Re: Case No. 20-1679-EL-BGN - In the Matter of the Application of Pleasant Prairie Solar Energy LLC for a Certificate of Environmental Compatibility and Public Need to Construct a Solar-Powered Electric Generation Facility in Franklin County, Ohio.

Response to Sixth Data Request from Staff of the Ohio Power Siting Board

PLEASANT PRAIRIE SOLAR ENERGY LLC 'S RESPONSE TO THE SIXTH DATA REQUEST FROM THE STAFF OF THE OHIO POWER SITING BOARD

Geological Features Map

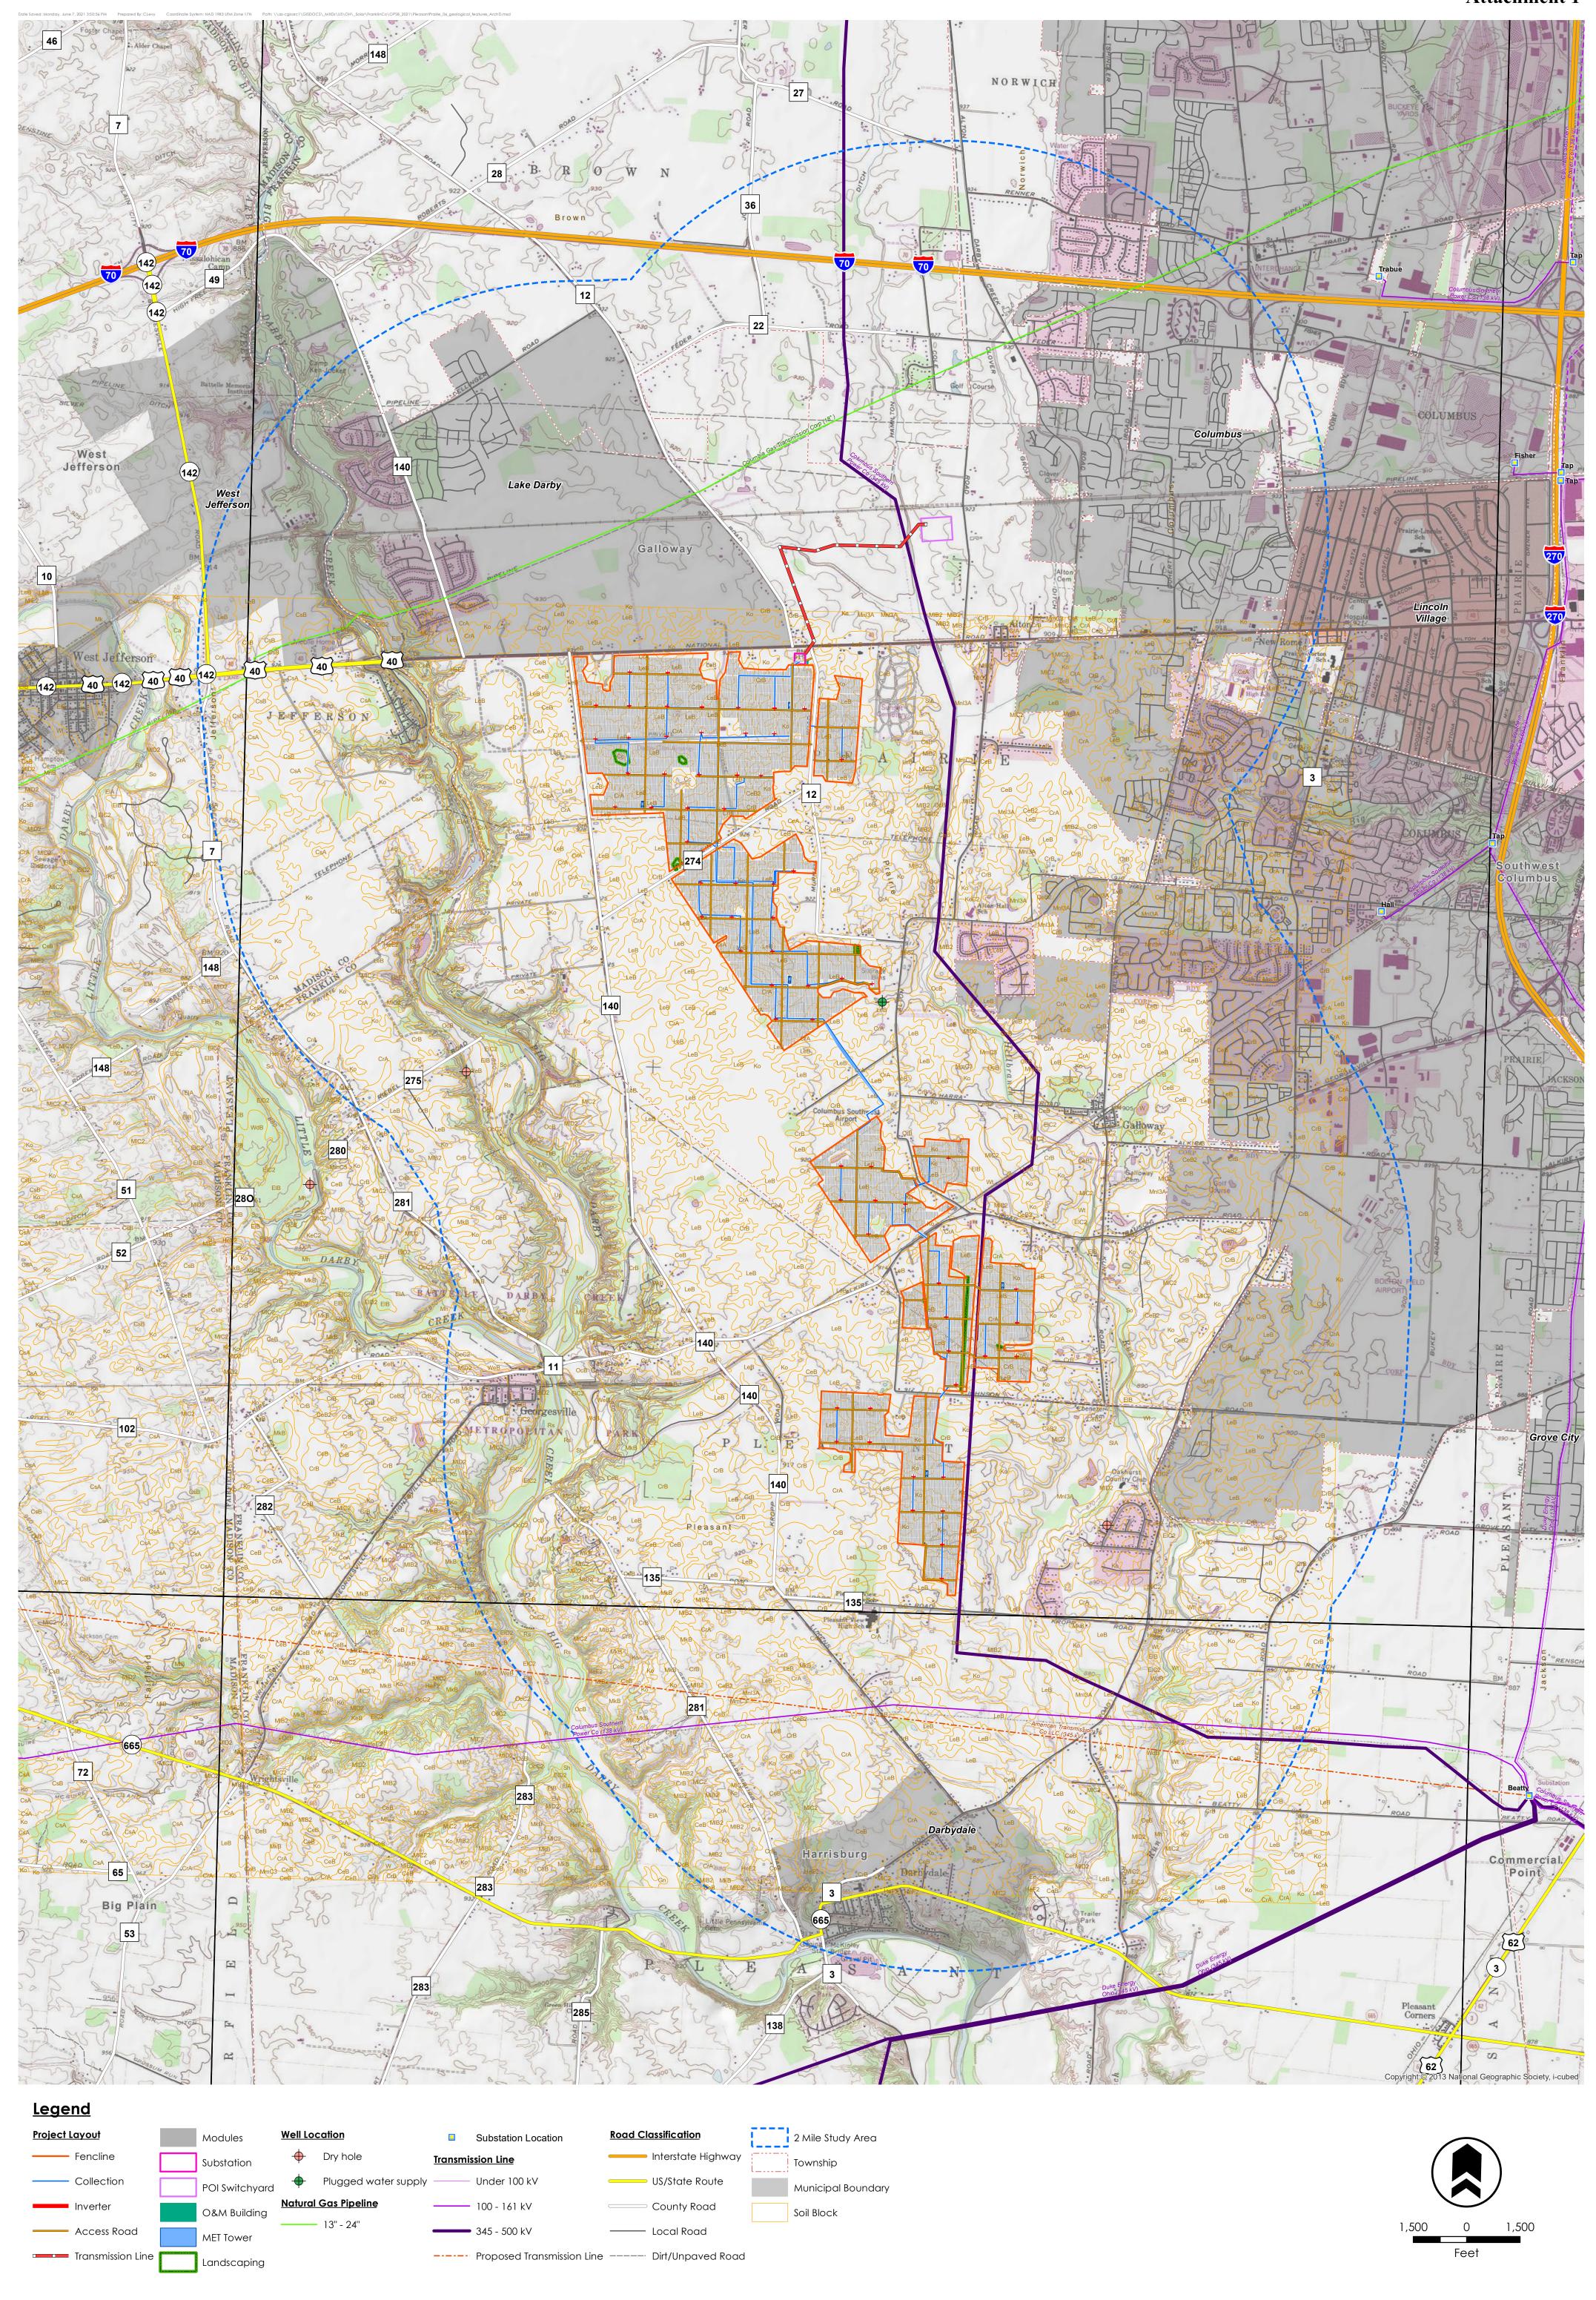
7. In reviewing Figure 08-1, oil and gas well locations in particular, it appears the Applicant didn't account for a plugged oil and gas well near Alton Road. API #34049600090000. Please confirm the existence of this well by revising the application accordingly. Also, please include the distance of this well from the nearest proposed solar equipment.

Response: This well is plugged and abandoned and below grade (covered by active agricultural area). The Well is located on parcel #1165754839, which is an easement parcel and outside the Project fence line; see Attachment 1 that includes a revision to Figure 08-1. Attachment 1 replaces and supersedes Figure 08-1 that was filed with the Application on February 19, 2021. The well is 244 feet south of the fence line and 1,500 feet east of the planed easement through the parcel.
